**FINAL ENGINEERING PLANS
FOR
SUMMIT HOUSING GROUP - MULTIFAMILY SITE**

TRACT A, BLOCK 3

LYONS VALLEY PARK FILING NO. 8

COVER SHEET
SUMMIT HOUSING GROUP
LYONS VALLEY PARK FILING NO. 8
LYONS, COLORADO

**CIVIL SITE PLAN
SUMMIT HOUSING GROUP
LYONS VALLEY PARK FILING NO. 8
LYONS, COLORADO**

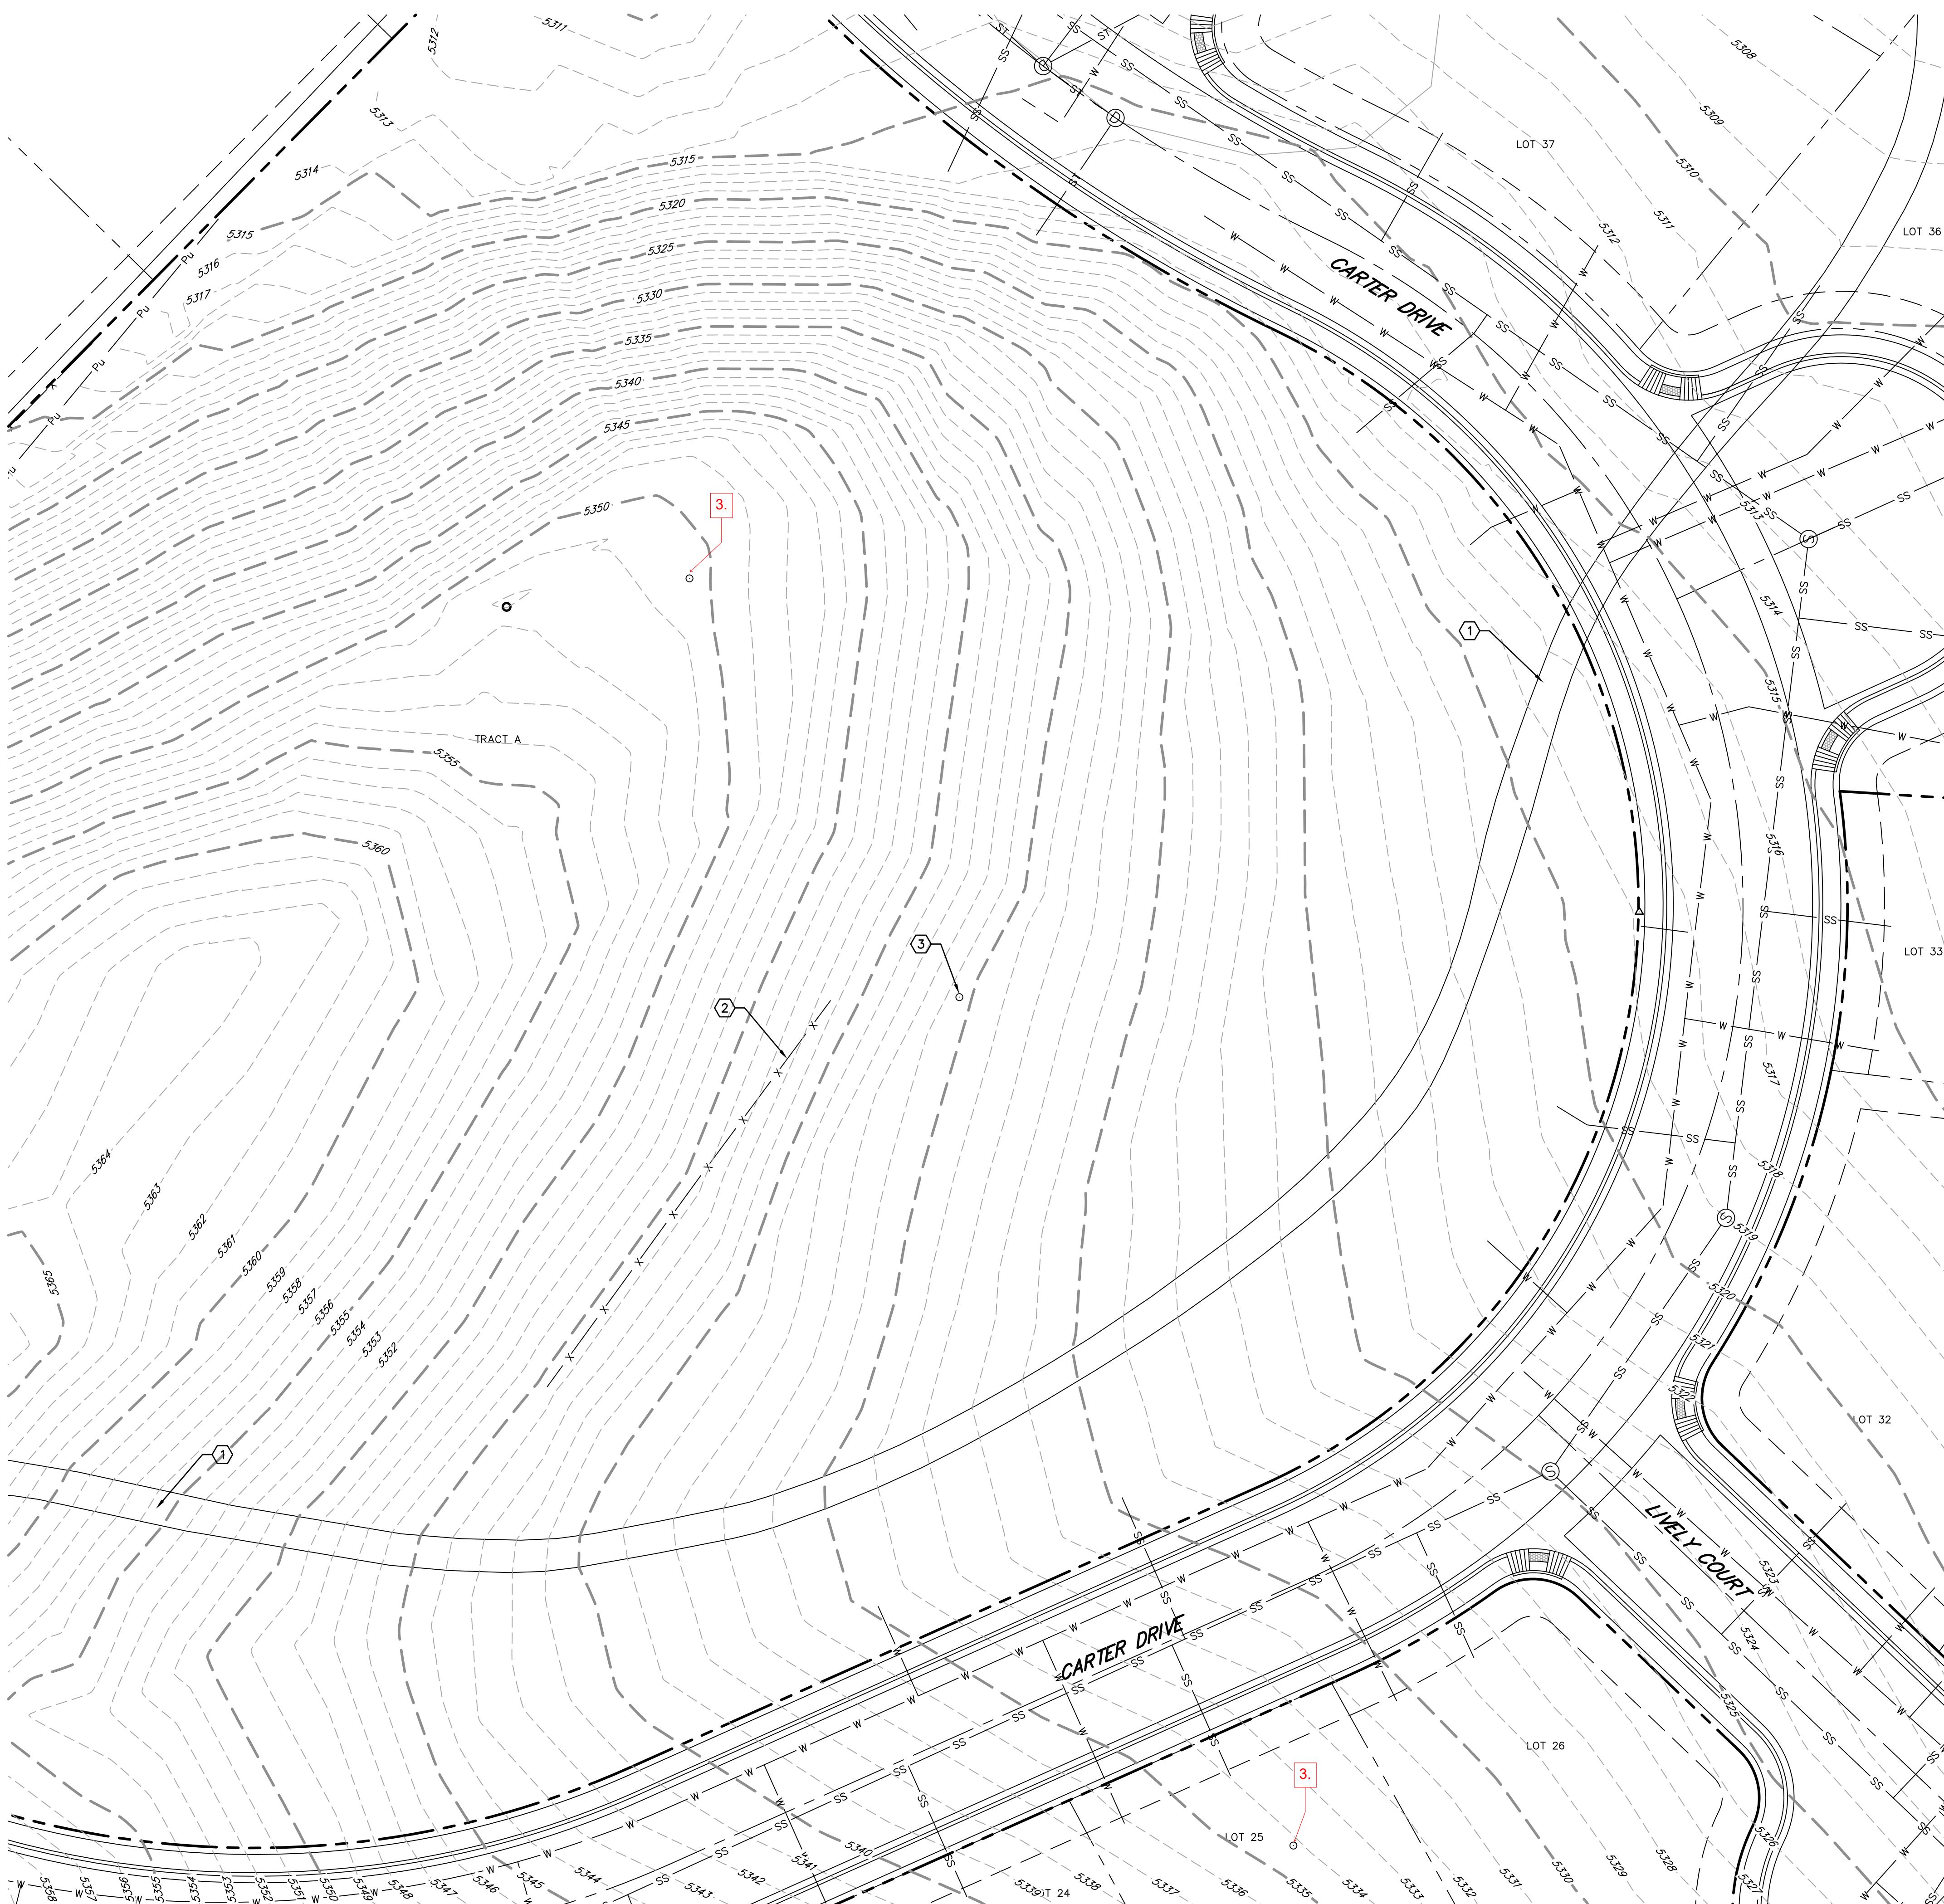
Roadway hatching does not provide enough contrast to show water main and storm sewer clearly. Please remove hatching or change the linetypes of the water main and storm sewer for clarity.

STORMWATER MANAGEMENT PLAN SUMMIT HOUSING GROUP LYONS VALLEY PARK FILING NO. 8 LYONS, COLORADO

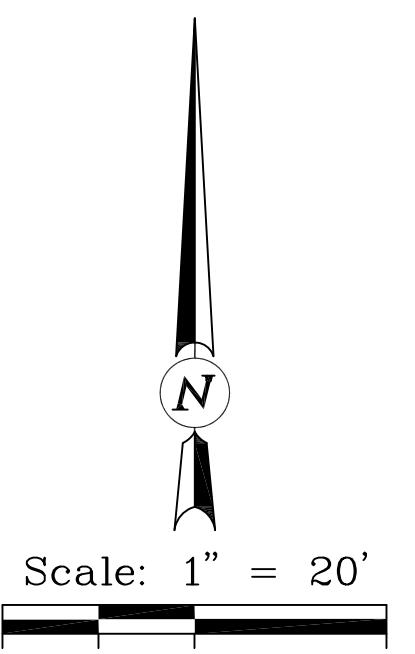
Please provide calculations for the coefficients presented in item number 4 and update all items per current plan set.

**SAN SEWER PLAN AND PROFILE
SUMMIT HOUSING GROUP
LYONS VALLEY PARK FILING NO. 8
LYONS, COLORADO**

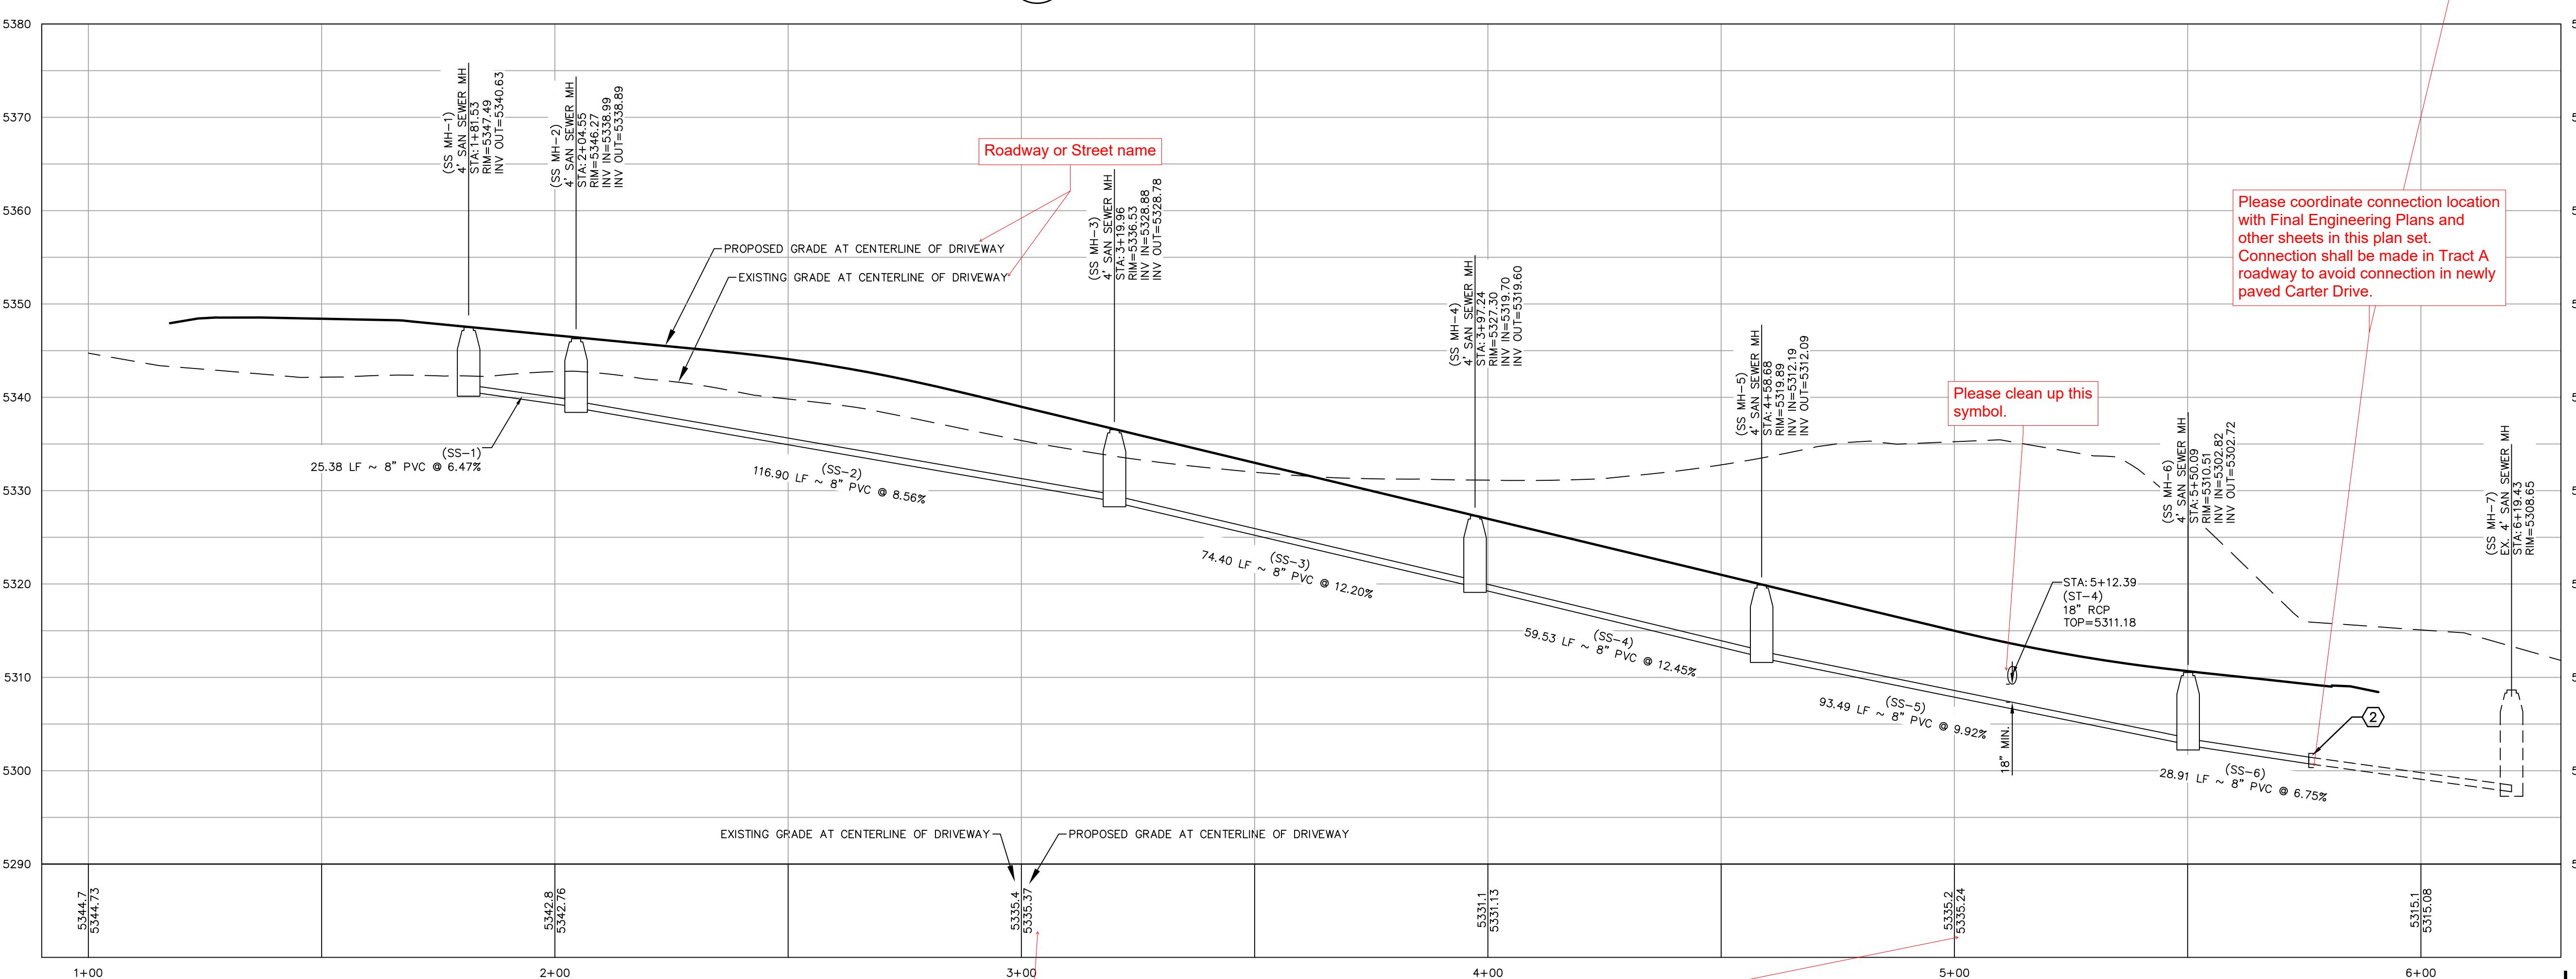
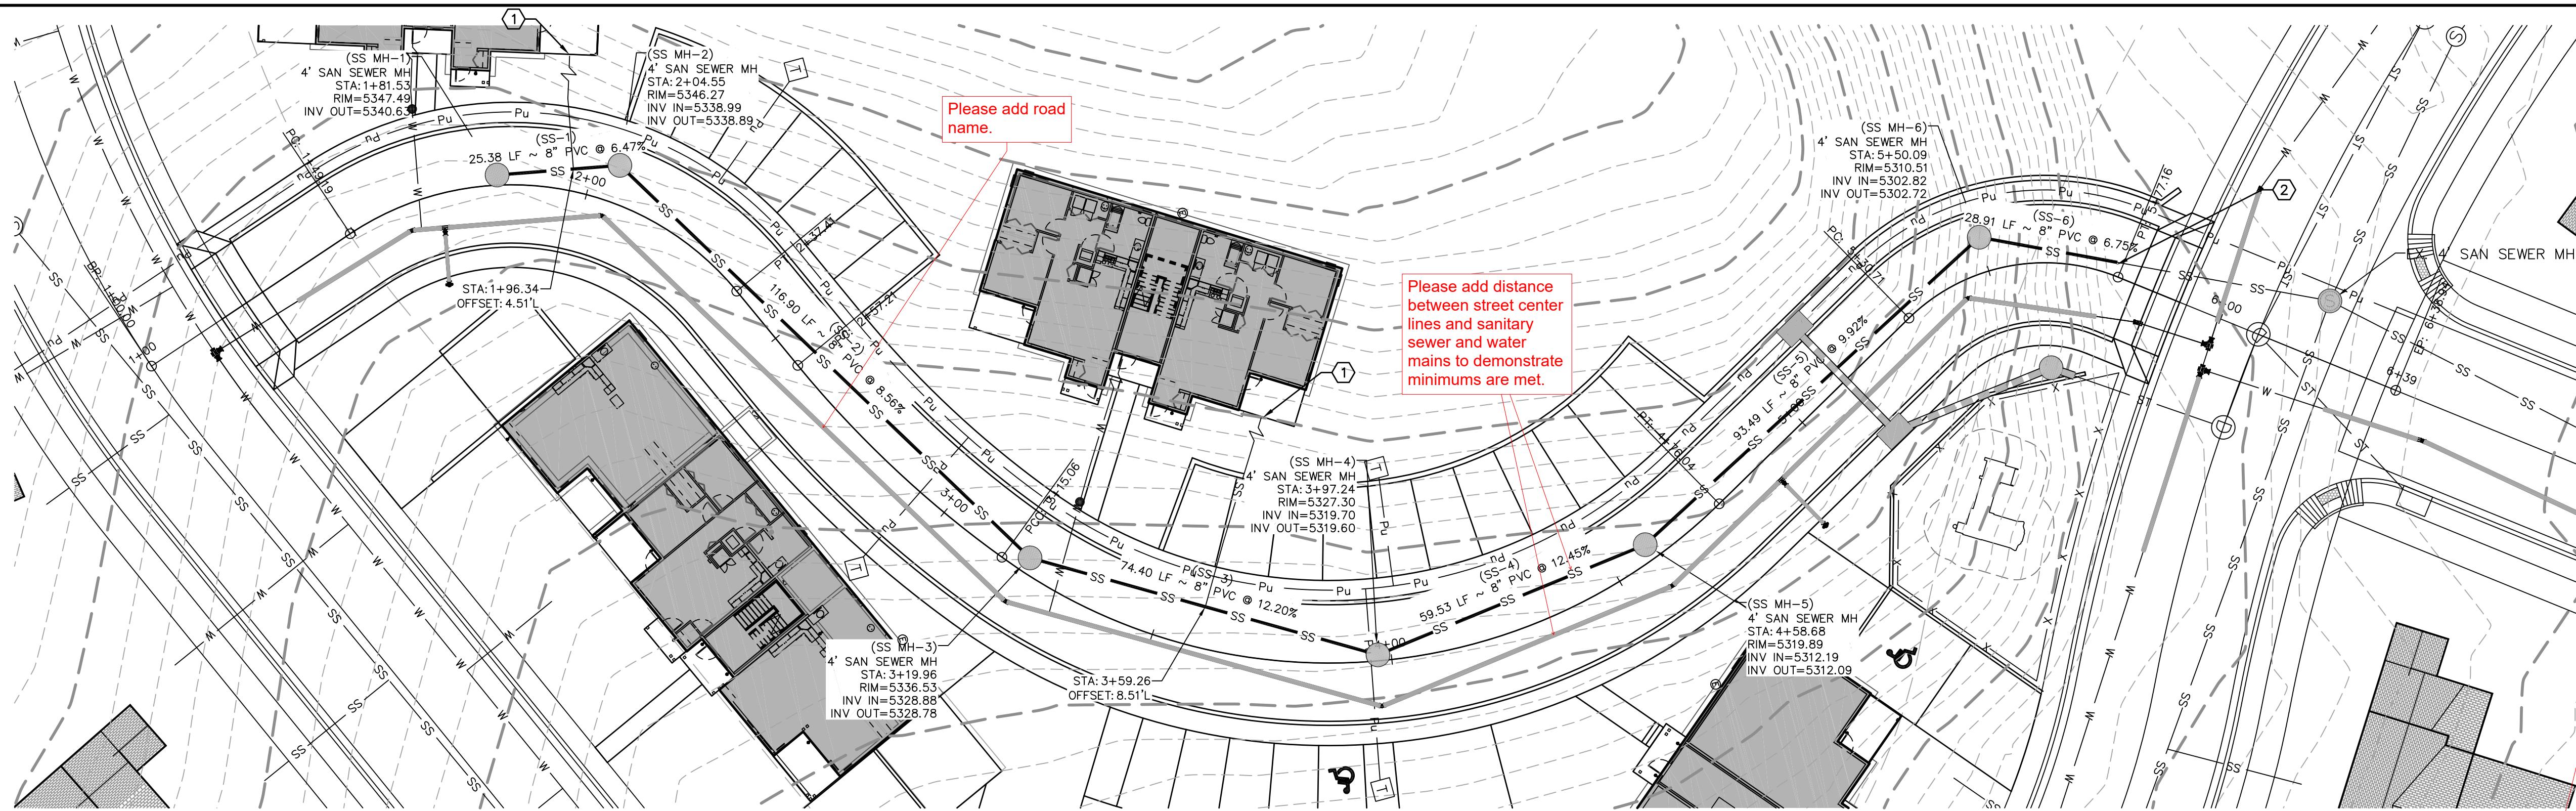
The Town of Lyons Water Distribution System Construction Design Standards state that sanitary sewer lines must have a minimum of 4.5 feet from finished grade directly above the pipe to the top of the pipe. Please show the proposed grade at the centerline of the sanitary sewer line with the required clearance or label the points of minimum and maximum cover on each profile to demonstrate that minimum and maximum cover are not exceeded.
